Subj: PROPOSED PLAN FOR SITE 9, NAVAL AIR STATION, BRUNSWICK, ME

**RESPONSE TO U.S. ENVIRONMENTAL PROTECTION AGENCY
COMMENTS ON SITE 9 DRAFT PROPOSED REMEDIAL ACTION PLAN**

**RESPONSE TO STATE OF MAINE DEPARTMENT OF
ENVIRONMENTAL PROTECTION COMMENTS ON
DRAFT PROPOSED REMEDIAL ACTION PLAN FOR SITE 9**

**RESPONSE TO LEPAGE ENVIRONMENTAL SERVICES, INC.
COMMENTS ON DRAFT PROPOSED REMEDIAL ACTION PLAN FOR SITE 9**

These areas are described in the following paragraphs, and the layout of Site 9 is shown on Figure 1.

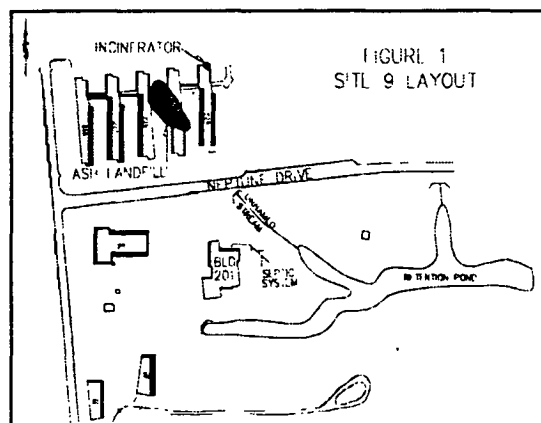
The figure shown is inaccurate as showing only one pond; whereas two dams (not shown) has created two ponds of distinctly different heads. The Navy needs to add the dams, and label both ponds. The Navy should also include information regarding the change in surface water elevations and when this change occurred.

14. **Page 3, Site History**—The description of the unnamed stream and the two retention ponds in the text and the location of the pond shown on Figure 1 are confusing. Figure 1 should be corrected to show the location of the dam adjacent to Site 9 and the text should indicate that the location of the southern stream is now part of the upper pond. Additional information should be provided regarding when the ponds were constructed and how they affect ground and surface water conditions at the site.

Response—The figure will be revised to note the dam locations and the presence of the upper and lower retention ponds. The text of the paragraph will note these ponds were constructed in 1997.

Response—The figure will be revised. Please see response to MEDEP Comment No. 14.
